TRAILSIDE PHASE 2

ADMINISTRATIVE DESIGN REVIEW - RECOMMENDATION RESPONSE

SDCI #3032268-LU / 6761362-PH

NORTHEAST CORNER FROM 25TH AVE - LOOKING SOUTHWEST

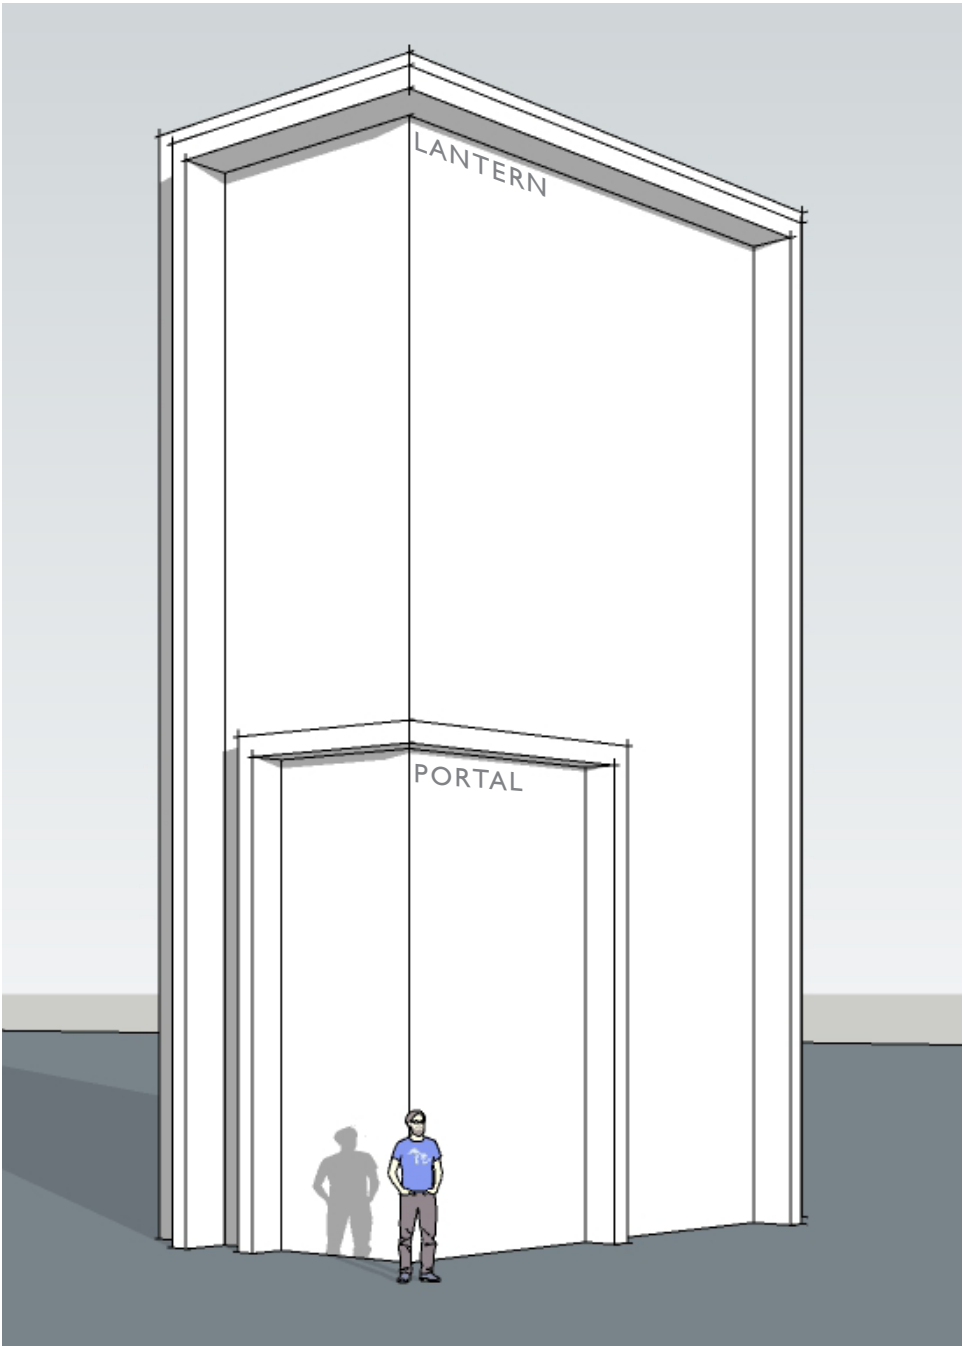
RECOMMENDATION: DEVELOP A DIFFERENT DESIGN LANGUAGE FOR THE NORTHEAST CORNER THAT DOES NOT FEATURE A FULL-SIZE LANTERN ELEMENT AND DRAW MORE ATTENTION TO SECONDARY RESIDENTIAL ENTRY.

RESPONSE: LANTERN HAS BEEN REMOVED. TWO STORY “MICRO-LANTERNS” INCORPORATING PORTAL ELEMENTS AND CANOPIES HAVE BEEN ADDED ALONG BOTH SIDES OF THE NORTHEAST BRICK MASSING ELEMENT.

PROCESS IMAGES

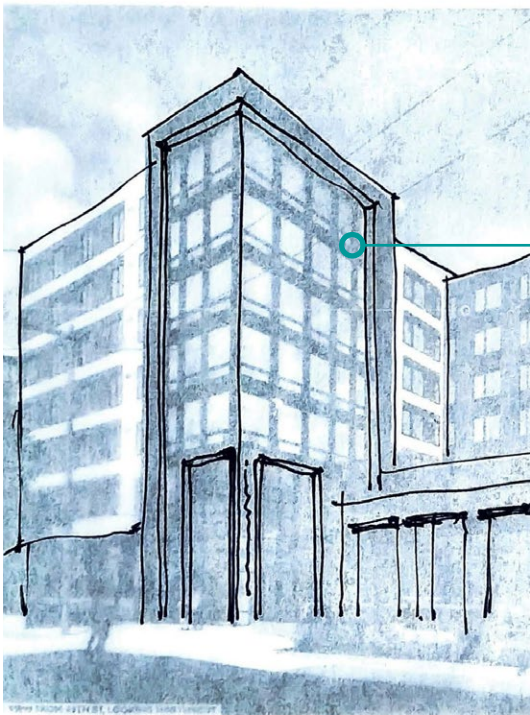
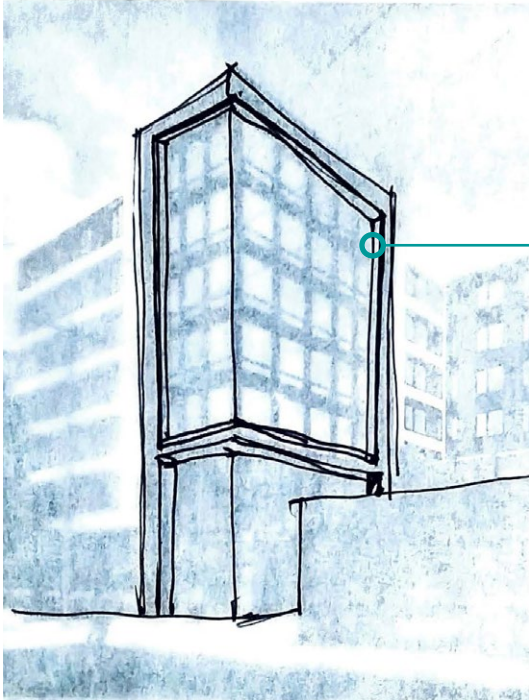
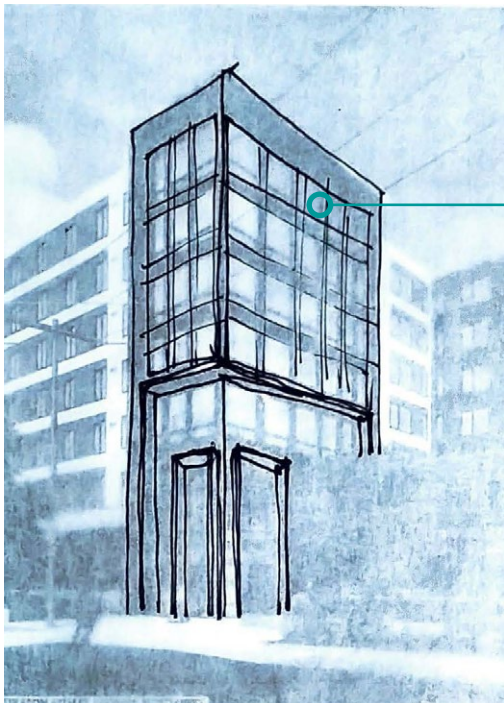
RECOMMENDATION: DEVELOP A LANTERN DESIGN THAT IS MORE UNIQUE FROM TRAILSIDE PHASE I.

Checkerboard pattern of glazing within lantern

Large lantern as designed, but with two 'portals' indicating entries

Three-story lantern, with masonry punches above

As designed, with improvements to doors, windows, lighting and signage

MAIN ENTRY LANTERN AND PLAZA - LOOKING NORTHWEST

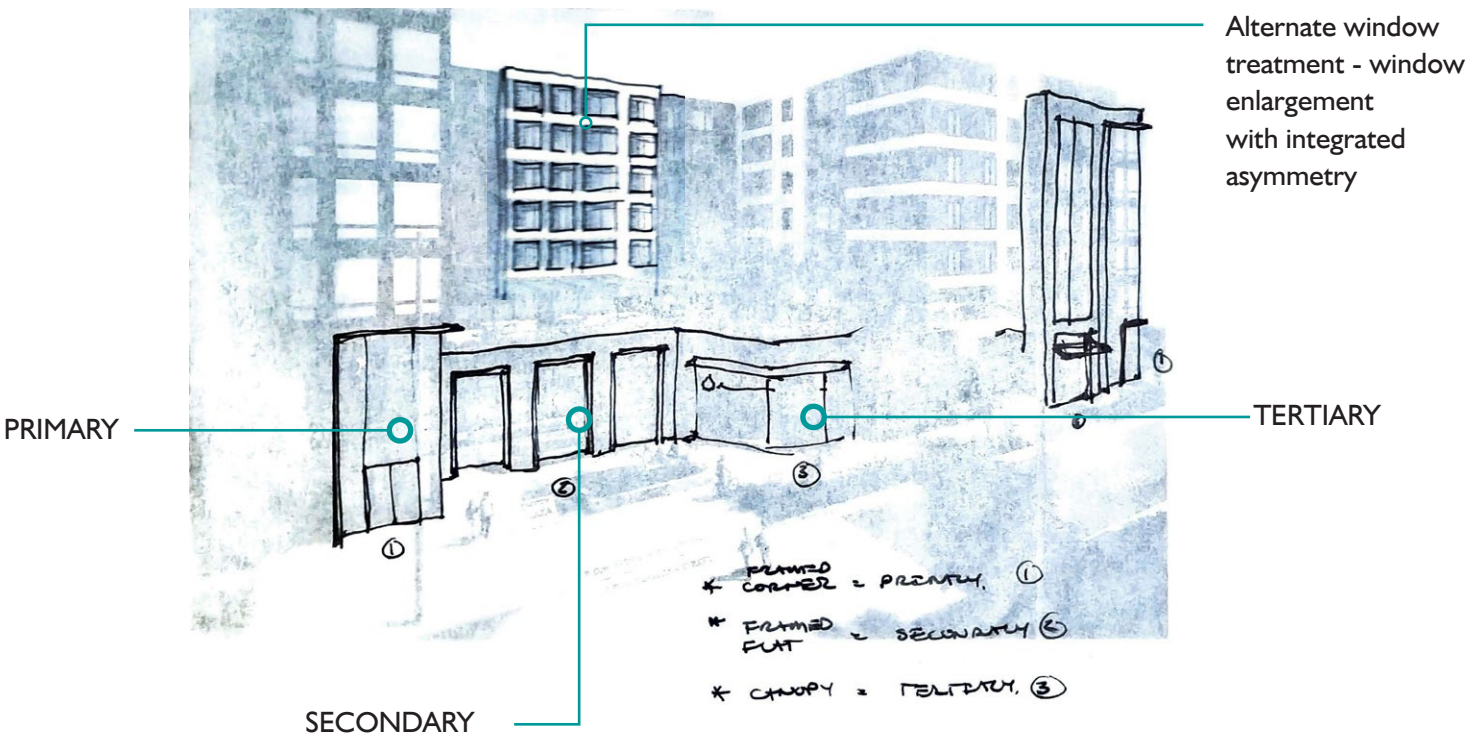
RECOMMENDATION: REDESIGN ENTRY PLAZA AND ENTRY TO INCREASE CONNECTION TO INDOOR SPACE, PROVIDE A STRONGER CONNECTION TO THE LEVEL 2 TERRACE , AND CREATE A MORE PRONOUNCED MAIN ENTRY.

RESPONSE: THE MAIN ENTRY PORTAL HAS BEEN EXTENDED TO ENGAGE THE LEVEL 2 TERRACE AND INCREASE TRANSPARENCY INTO THE AMENITY SPACE AND INTERIOR FEATURE STAIR TO LEVEL 2.

MAIN ENTRY LANTERN AND PLAZA - LOOKING NORTHWEST

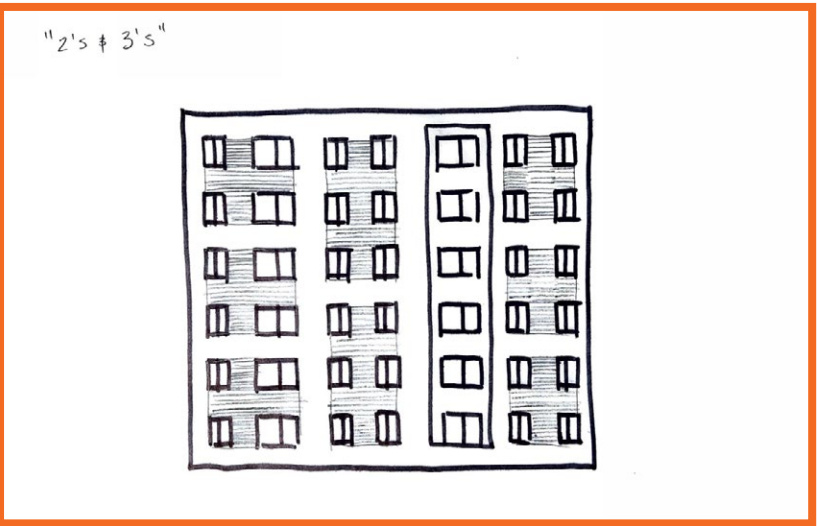
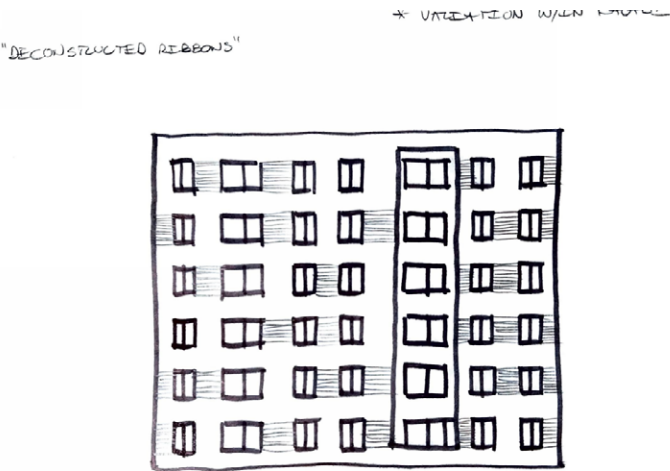
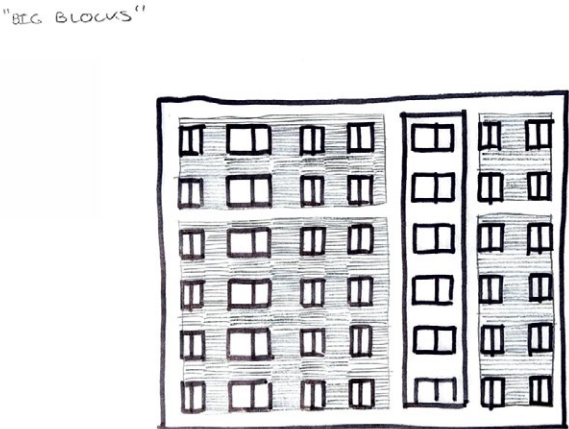
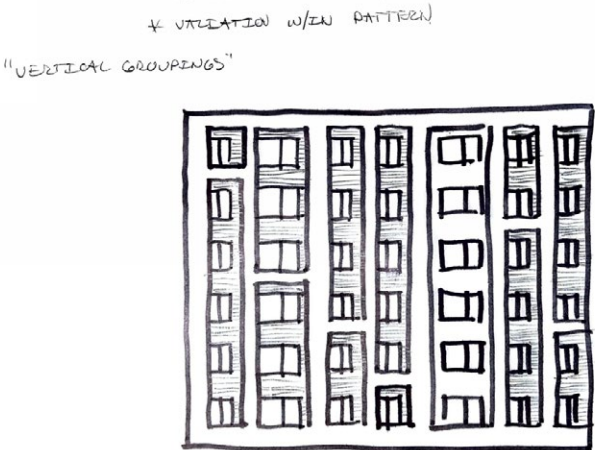
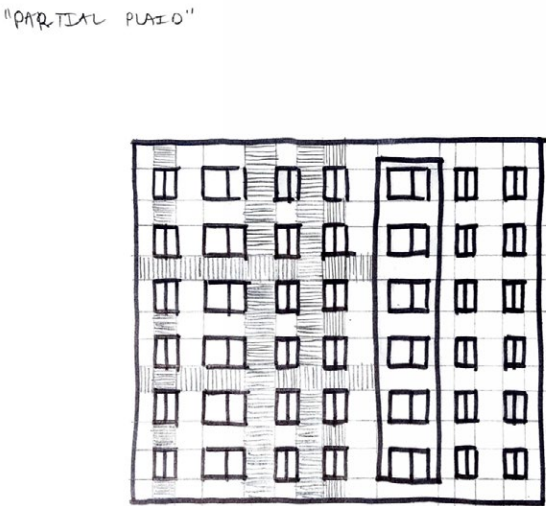
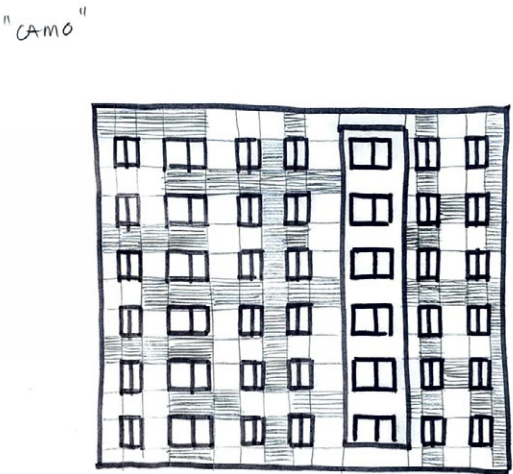
RECOMMENDATION: DEVELOP A MORE UNIQUE APPROACH TO THE FACADE PATTERNING, MATERIALS, AND WINDOW GROUPING TO FURTHER DISTINGUISH PHASE II FROM PHASE I.

RESPONSE: HORIZONTAL BANDING HAS BEEN ELIMINATED. WOOD SIDING HAS BEEN GROUPED IN BLOCKS AROUND WINDOWS AND A SMALLER DARK BLOCK OF COLOR HAS BEEN ADDED OVER WINDOWS FOR ADDITIONAL CONTRAST.
